HEARING DATE: April 18, 2024

TO: Planning & Zoning Commission

SUBJECT: Pebblebrook Subdivision – AZ, PP
[H-2024-0005](#)

Annexation of 13.94-acres of land with an R-8 zoning district; and Preliminary Plat consisting of 54 building lots and 6 common lots on 13.94-acres of land.

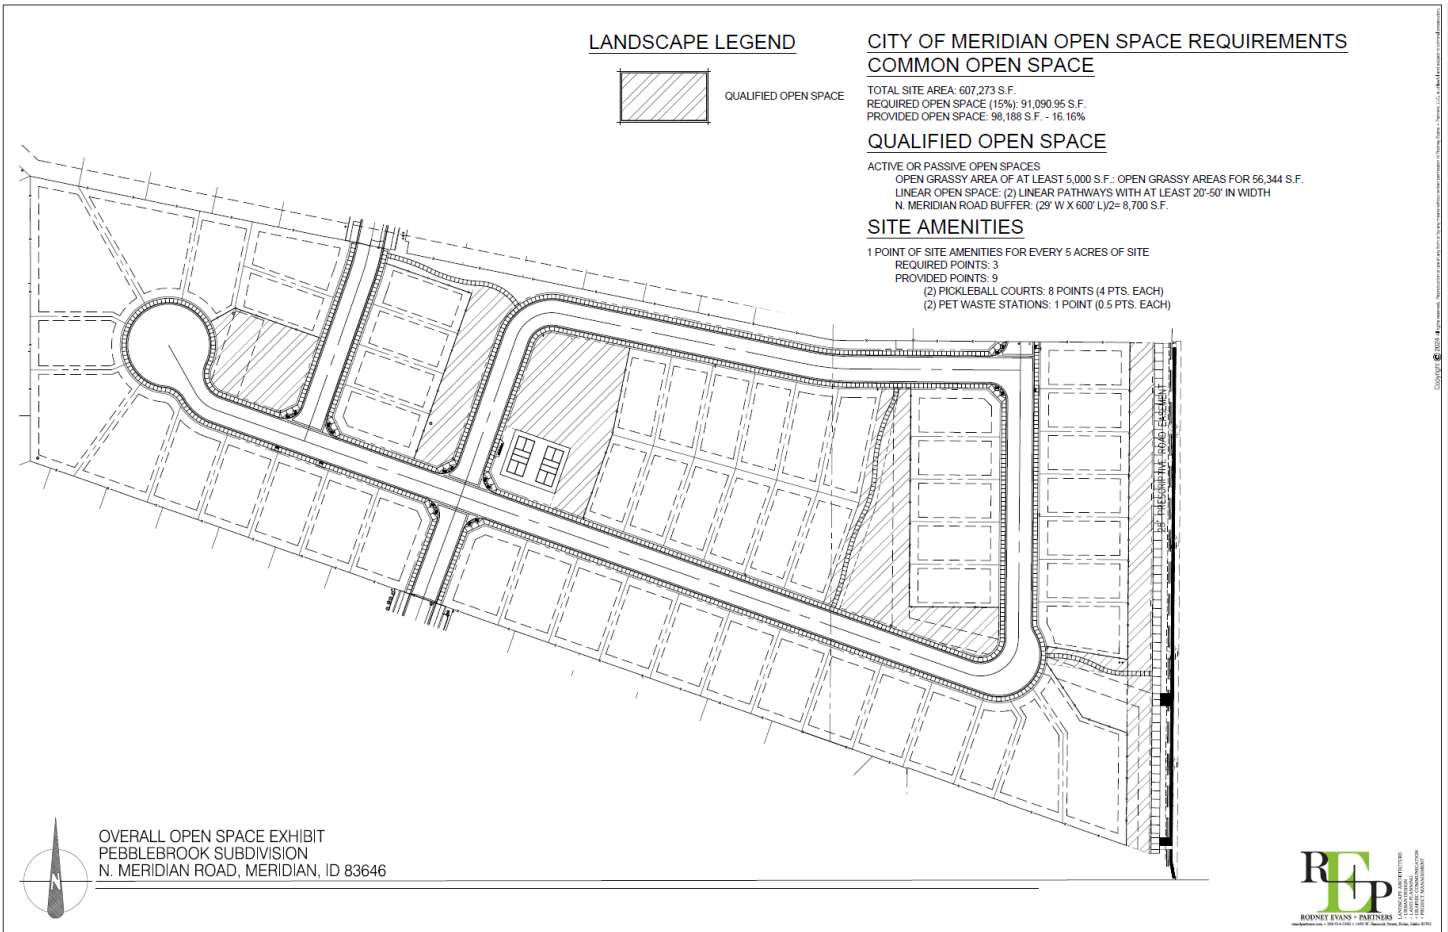
*The proposed site design generally provides a good transition in density and lot sizes to abutting lots at 1:1 and 2:1 ratios; however, there are a couple of areas (Lots 7-9, Block 2 abutting Lot 10, Block 49 in Paramount #21 and Lots 10-12, Block 2 abutting two lots in Bordeaux Estates to the south) where 3 lots abut 1 lot. **The lots in these areas should be revised (or lots removed) to reflect a maximum 2:1 ratio.***

Road Improvements: ACHD is requiring Meridian Rd. to be improved with 17’ of pavement from centerline with a 3’ gravel shoulder and 10’ wide detached sidewalk; only 6’ of pavement and a 3’ wide shoulder is required at this time – curb and gutter will be added later when Meridian Rd. is fully expanded (see Detail 2 on Sheet PP.1 below).

Landscaping (UDC 11-3B): A 35-foot wide street buffer is required along N. Meridian Rd., an entryway corridor, measured from the ultimate back of curb. A 47.5’ wide buffer is proposed as shown on Detail 2 on Sheet PP.1 of the plat, as follows:

Landscaping is required to be provided within the buffer in accord with the standards listed in UDC [11-3B-7C.3](#), including the standards for entryway corridors. The proposed buffer incorporates a berm with a maximum 3:1 slope, a wrought-iron fence at the back edge of the buffer, landscaping and boulders within the planter areas in accord with these standards. **If the unimproved street right-of-way is ten (10) feet or greater from the edge of pavement to edge of sidewalk or property line, the developer is required to maintain a ten-foot compacted shoulder meeting the construction standards of the transportation authority and landscape the remainder with lawn or other vegetative ground cover; the landscape plan should be revised accordingly.**

The landscape plan depicts a 5' tall open vision wrought iron fence at the back edge of the street buffer along N. Meridian Rd. and adjacent to internal common open space areas; and a 6' tall cedar privacy fencing is proposed along the northern boundary of the site abutting the County parcel. **Fencing appears to be missing in some areas adjacent to common open space areas; fencing should be provided to distinguish common from private areas in accord with UDC [11-3A-7A.7a](#).**

- b. Revise the configuration of Lots 7-9, Block 2 (abutting Lot 10, Block 49 in Paramount #21) and Lots 10-12, Block 2 (abutting two lots in Bordeaux Estates) to reflect a maximum 2:1 ratio.

3. The landscape plan submitted with the final plat application shall include the following revisions:
 - a. Depict lawn or other vegetative groundcover on the east side of the sidewalk along N. Meridian Rd. as set forth in UDC [11-3B-7C.5](#), which states, *“If the unimproved street right-of-way is ten (10) feet or greater from the edge of pavement to edge of sidewalk or property line, the developer is required to maintain a ten-foot compacted shoulder meeting the construction standards of the transportation authority and landscape the remainder with lawn or other vegetative ground cover.”*

- b. Depict fencing abutting all pathways and common open space lots to distinguish common from private areas in accord with UDC [11-3A-7A.7a](#).
 4. All irrigation ditches crossing this site shall be piped or otherwise covered as set forth in UDC [11-3A-6B.3](#).

D. Common Open Space & Site Amenities Exhibit

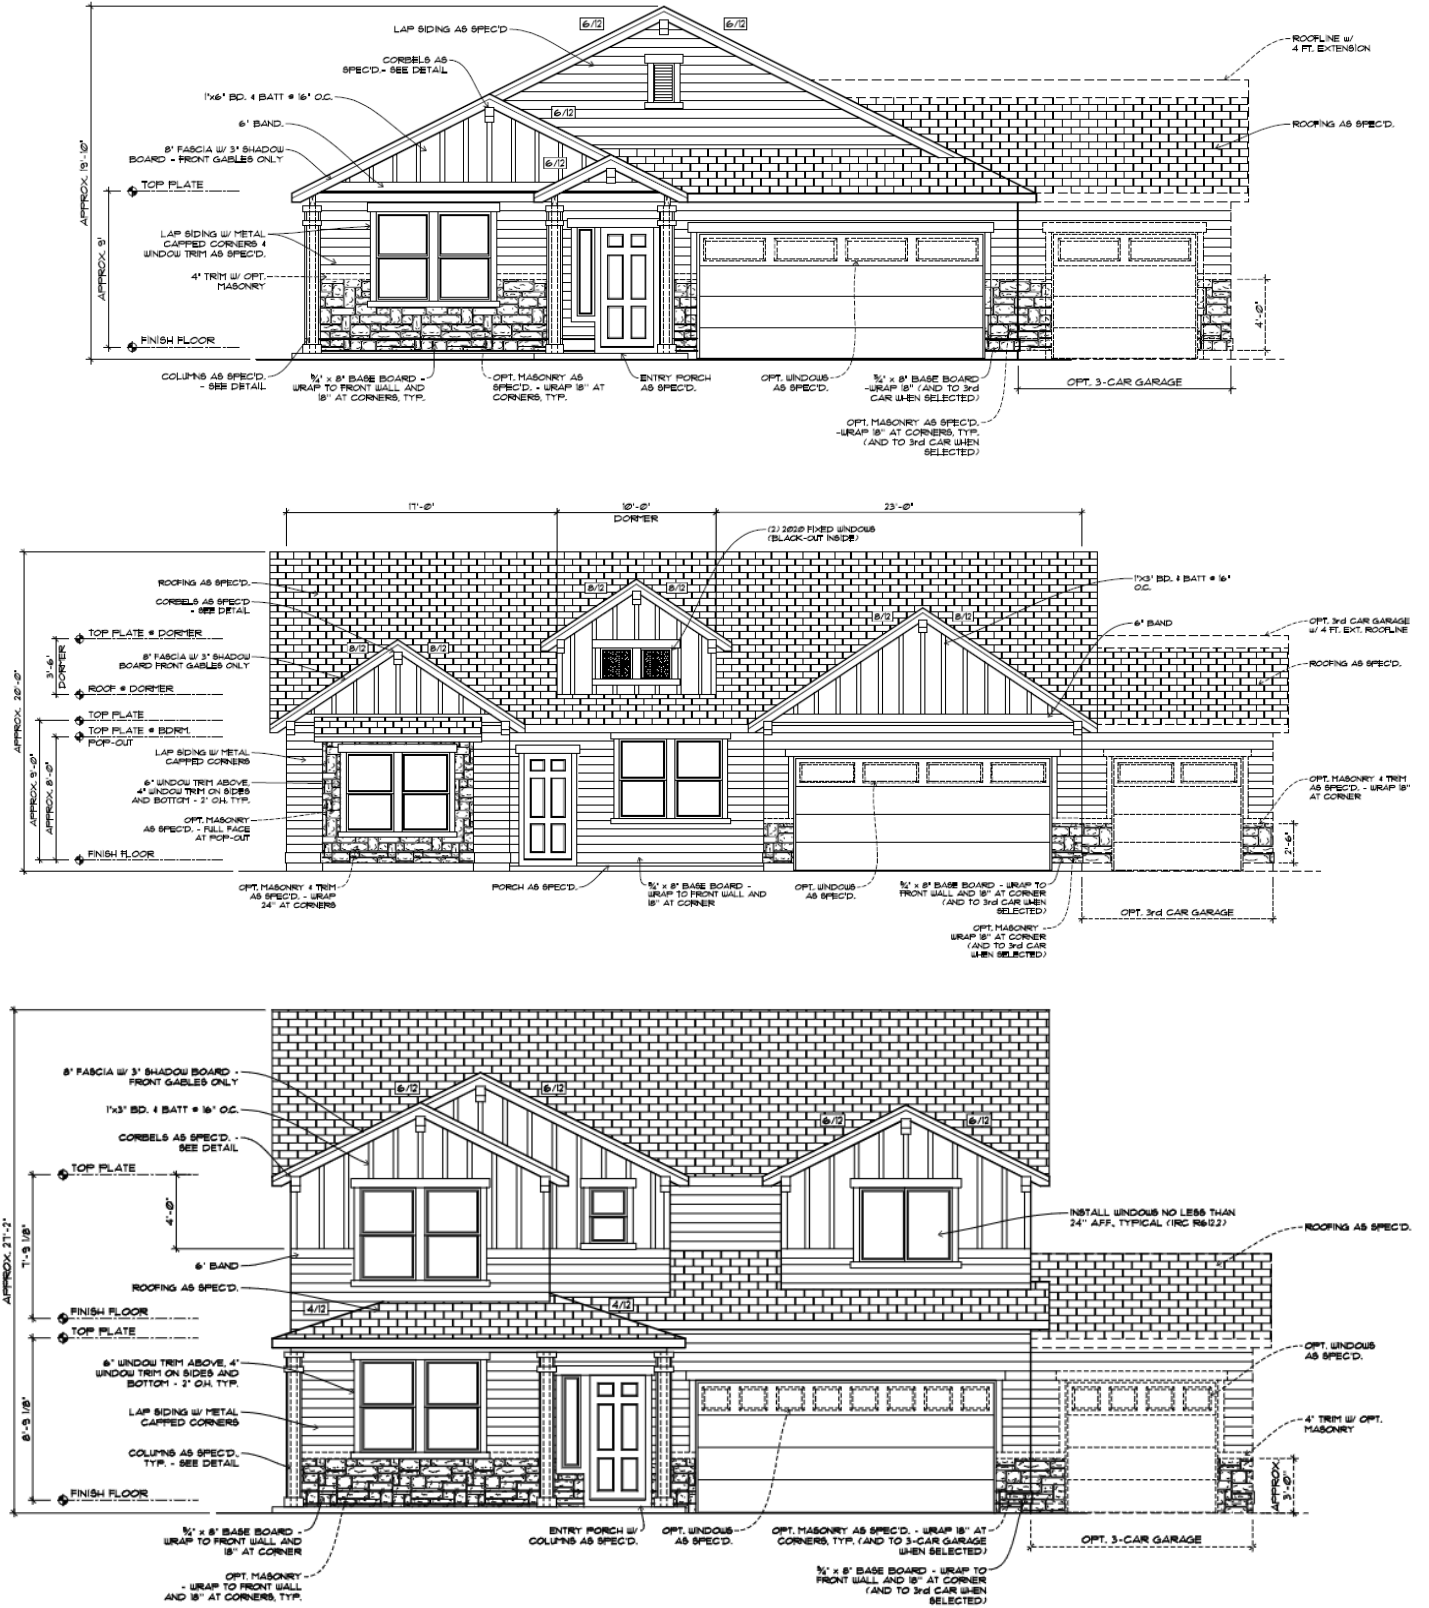
Common Open Space & Site Amenities (UDC 11-3G-3): Based on the standards in UDC Table 11-3G-3, a minimum of 15% (or 2.09-acres) of qualified open space is required to be provided within the development. An open space exhibit was submitted as shown in Section VIII.D, that depicts 16.16% (or 2.25-acres) of open space that meets the required quality and qualified open space standards.

Based on the standards in UDC [11-3G-4A](#), a minimum of two (2) points of site amenities are required to be provided. Two (2) sports courts (pickleball) (8 pts.) and (2) dog waste stations (1 pt.) are proposed, which total 9 points, exceeding UDC standards. **Per the standards for such in UDC 11-3G-4C, dog waste stations are installed in the ground fixtures with waste disposal bags and trash receptacles; and sports courts are required to have markings and include benches for seating. Details should be submitted with the final plat application that demonstrate compliance with these standards.**

5. With the final plat application, include a detail for the dog waste stations and sports courts that comply with the standards for such in UDC [11-3G-4C](#). *Dog waste stations are required to be installed in the ground fixtures with waste disposal bags and trash receptacles; and sports courts are required to have markings and include benches for seating.*

6. A minimum of 2.25-acres of qualified open space shall be provided within the development in accord with the open space exhibit included in Section VIII.D.

E. Conceptual Building Elevations

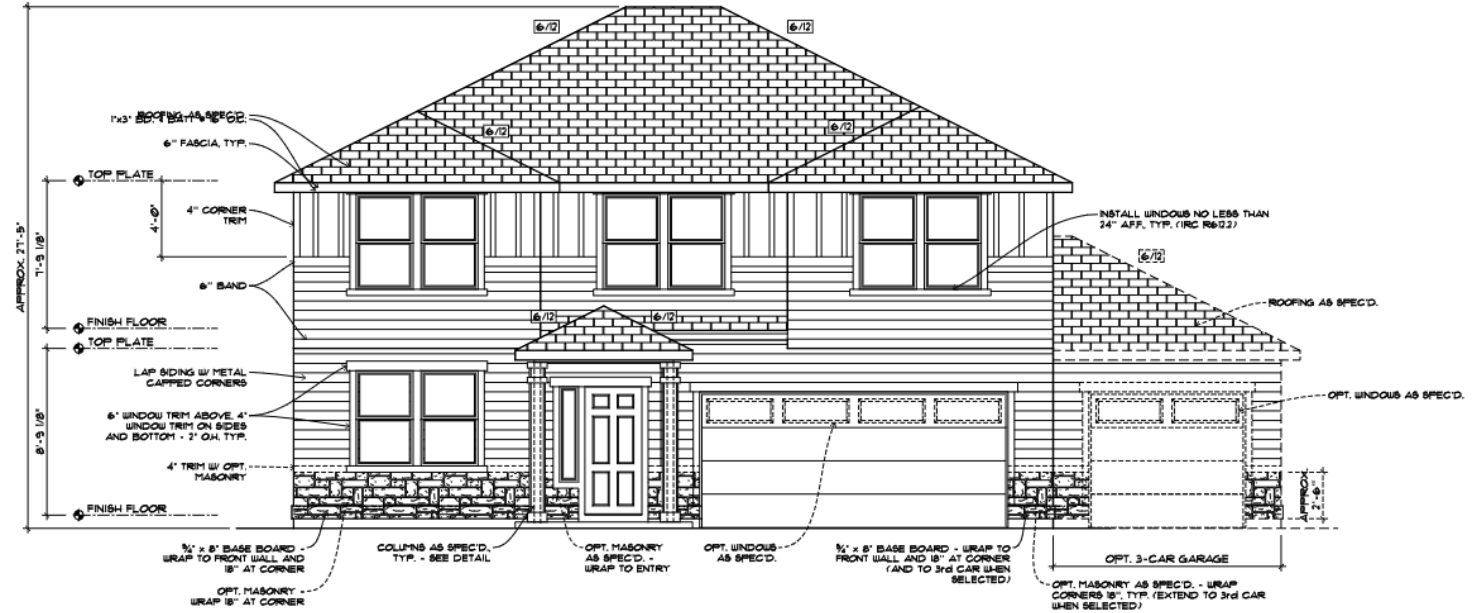
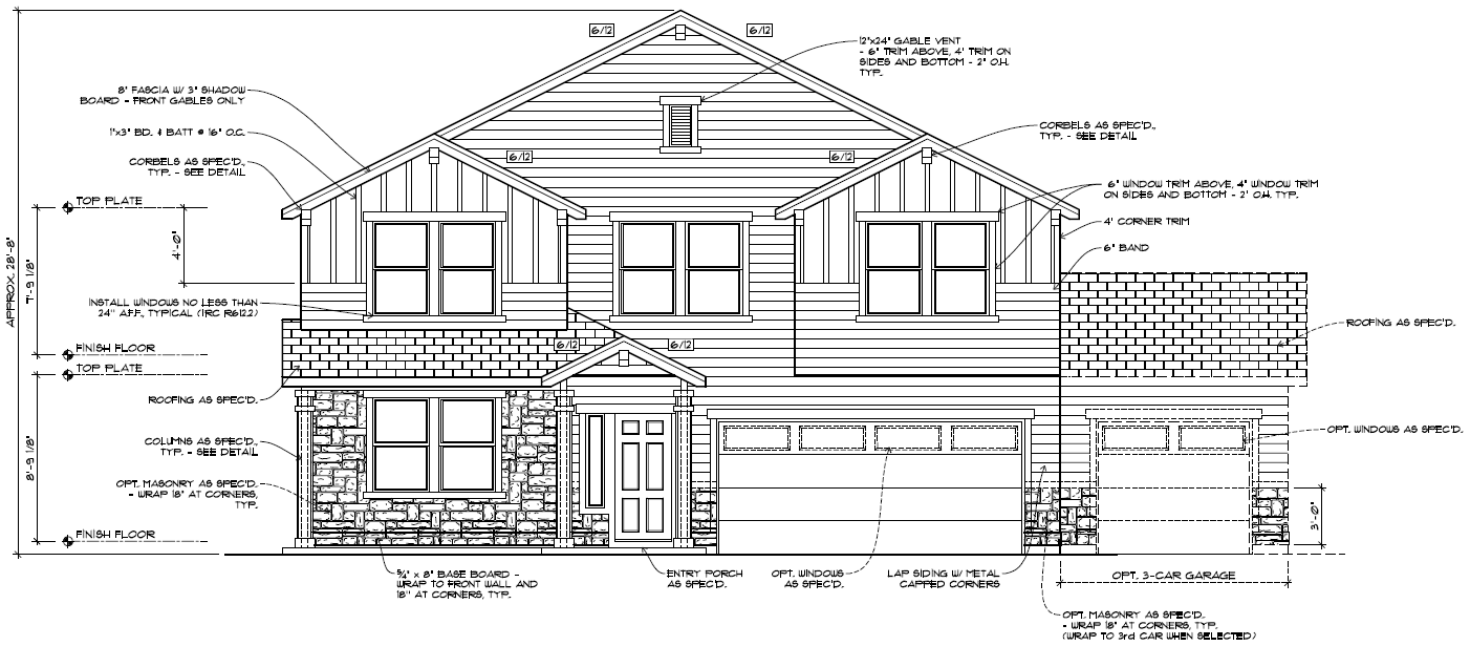
Building Elevations: Five (5) conceptual building elevations were submitted for the proposed 1- and 2-story homes with 2- and 3-car garages as shown in Section VIII.E. The homes are craftsman style with building materials consisting of a mix of board and batten siding, lap siding and optional masonry accents. The Applicant clarified that “optional” masonry accents depicted on the elevations is incorrect – all homes will have masonry accents consistent with the Paramount architectural guidelines. **To ensure this for a higher quality of development, Staff recommends masonry accents are required on all structures in the development.**

Design review is not required for single-family detached structures. However, because the rear and/or sides of homes facing N. Meridian Rd. will be highly visible, Staff recommends a DA provision requiring those elevations incorporate articulation through changes in two or more of the following: modulation (e.g. projections, recesses, step-backs, pop-outs), bays, banding, porches, balconies, material types, or other integrated architectural elements to break up monotonous wall planes and roof lines that are visible from adjacent public streets. *Single-story homes are exempt from this requirement.*

Note: Masonry accents shall be provided on all front elevations.

- b. Provide a 10-foot wide detached sidewalk within the required street buffer along N. Meridian Rd. as proposed.
 - c. All homes within the development shall include a mix of materials, including masonry accents, as proposed by the Applicant.

- d. The rear and/or sides of homes facing N. Meridian Rd. shall incorporate articulation through changes in two or more of the following: modulation (e.g. projections, recesses, step-backs, pop-outs), bays, banding, porches, balconies, material types, or other integrated architectural elements to break up monotonous wall planes and roof lines that are visible from the subject public streets. *Single-story homes are exempt from this requirement.*
